**Project**  
THE WEST MIDLANDS RAIL FREIGHT INTERCHANGE ORDER 201X

**Drawing Title** Drawing Size A1  
ACCESS AND RIGHTS OF WAY PLAN SHEET 2 - INSET A TO SHEET 1

Regulation 5 (2) (k)	Document 2.3B
Drawn NW Date: JUNE 2018 Scale 1: 1000	Reviewed JF
Drawn No. WSP-70001979-SK-060	Rev. F

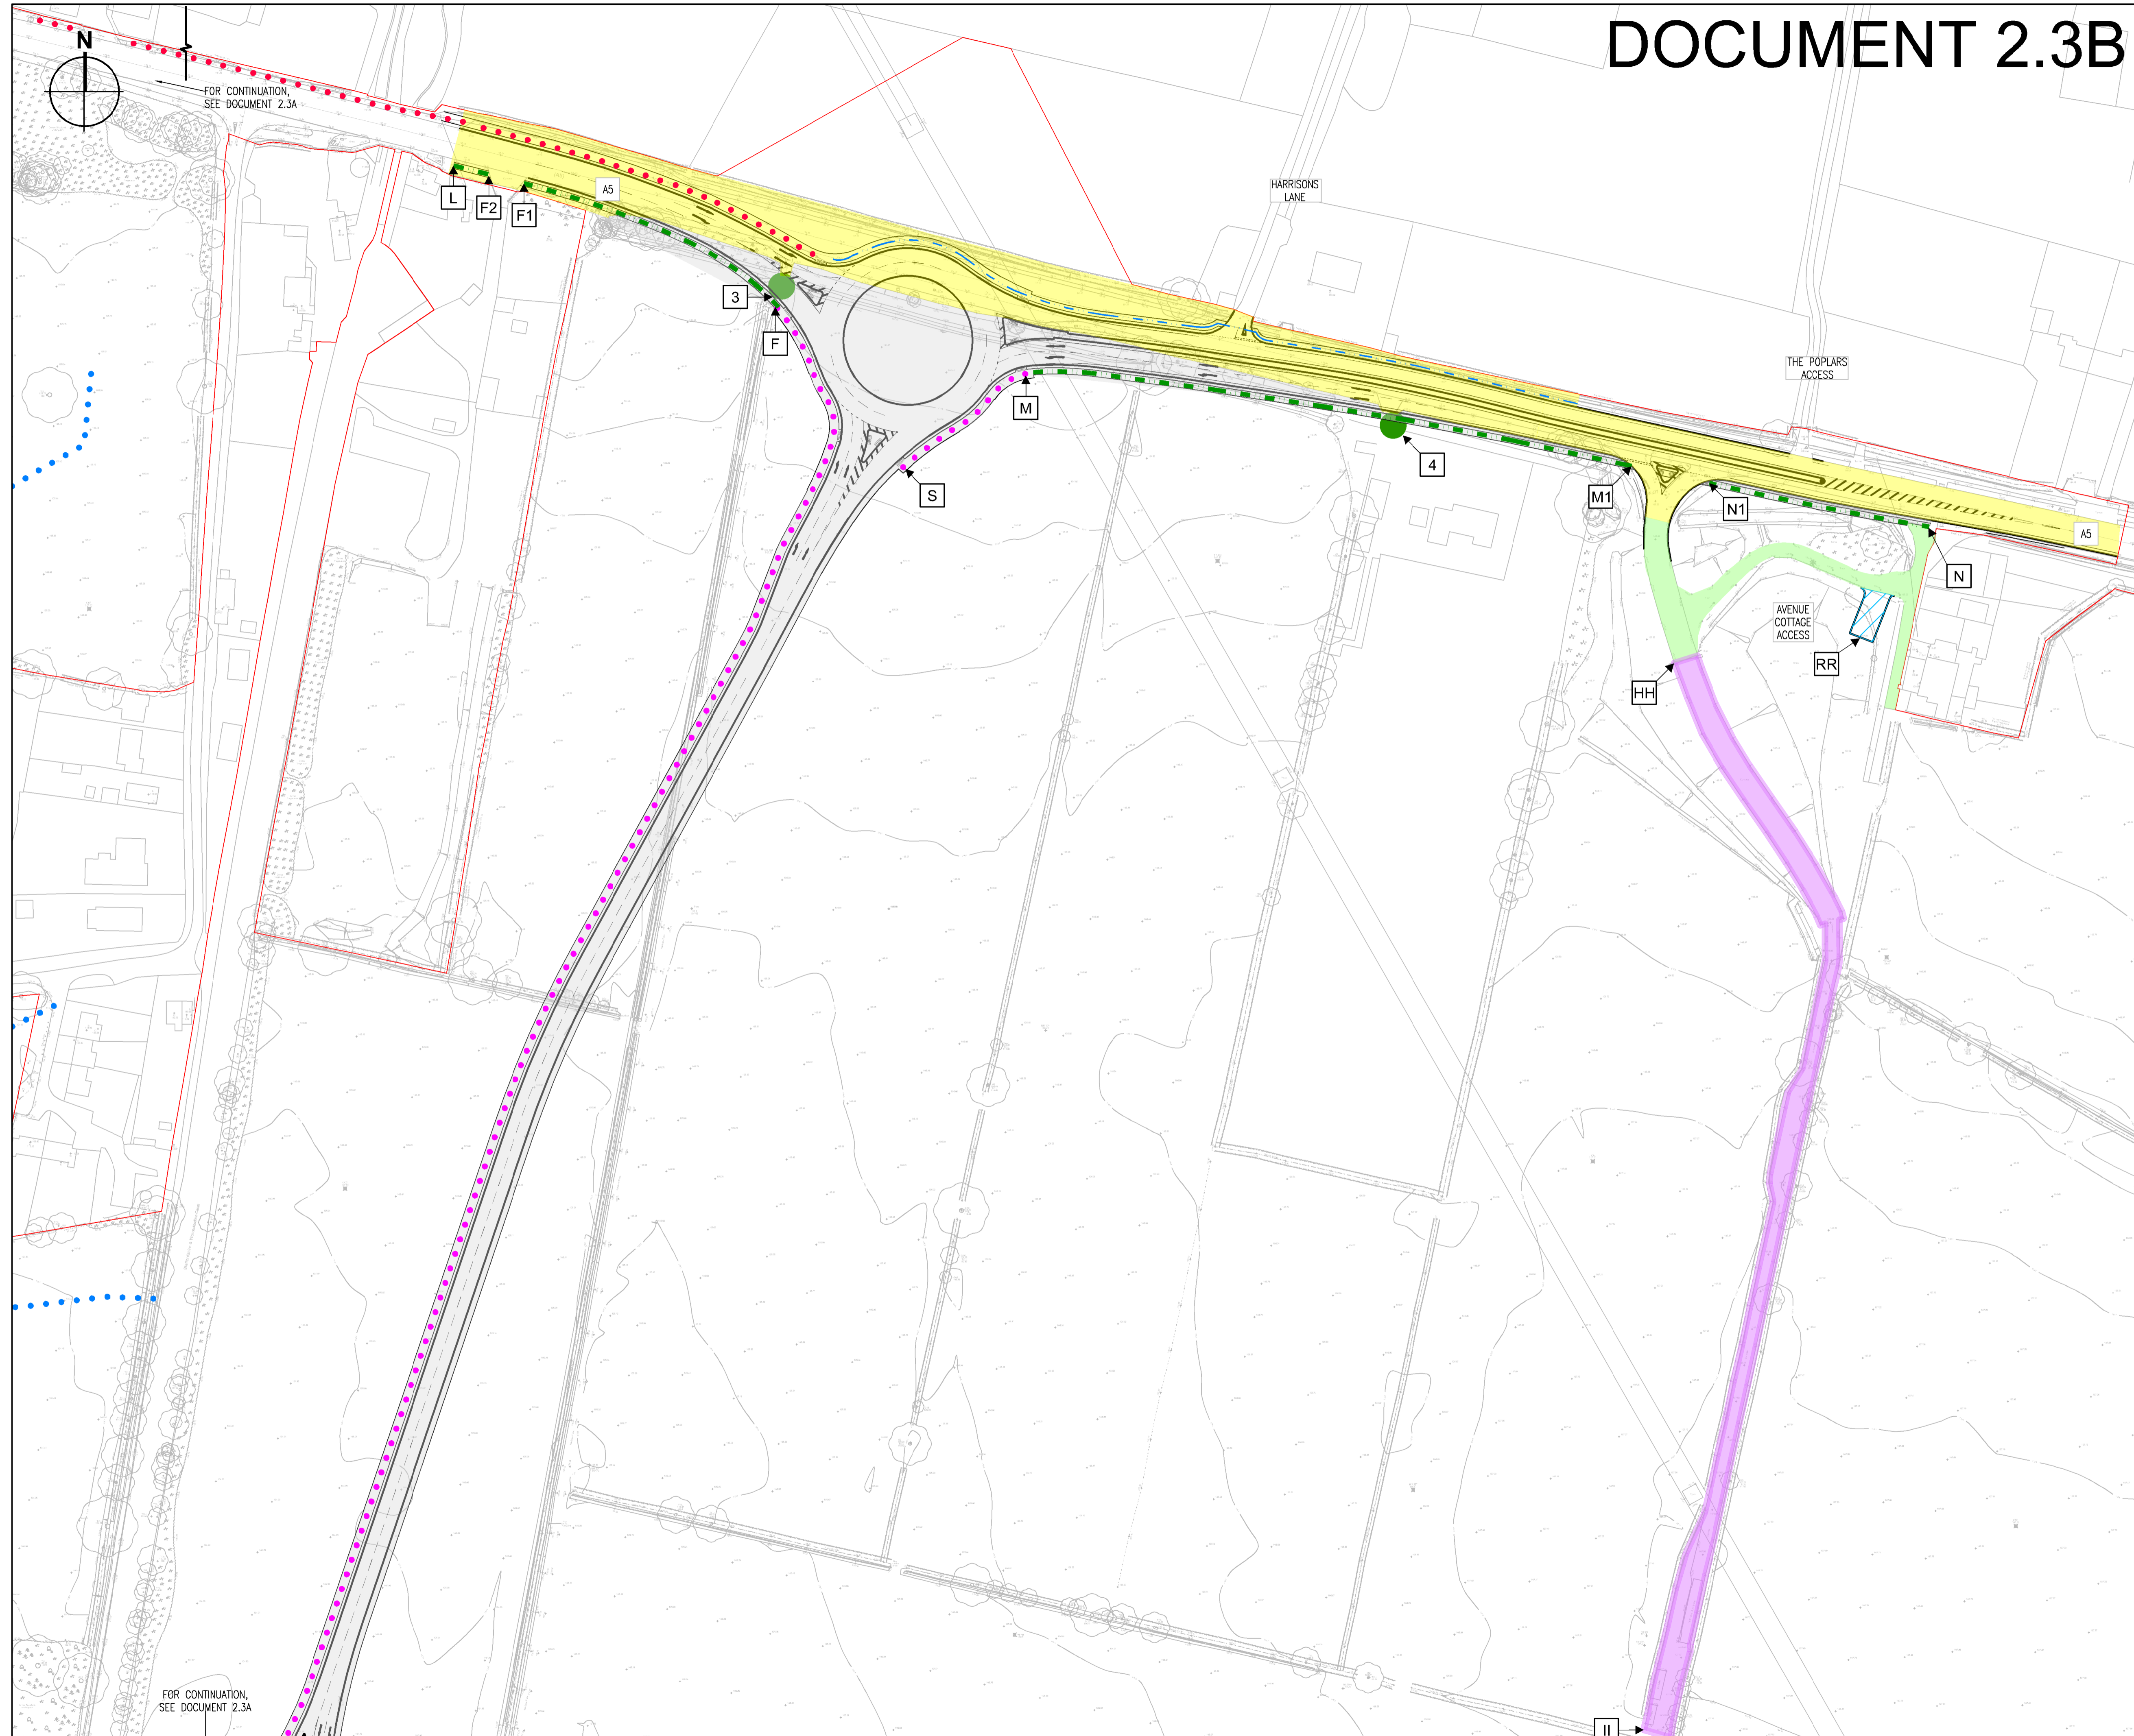
- MAY 2019 -
- ADDITIONAL AREA OF NEW ALL PURPOSE HIGHWAY ALLOCATED ON SOUTHERN EDGE OF THE APPROACH TO A5 ROUNDABOUT, FROM THE A5 EAST TO ENSURE VISIBILITY IS MAINTAINED.
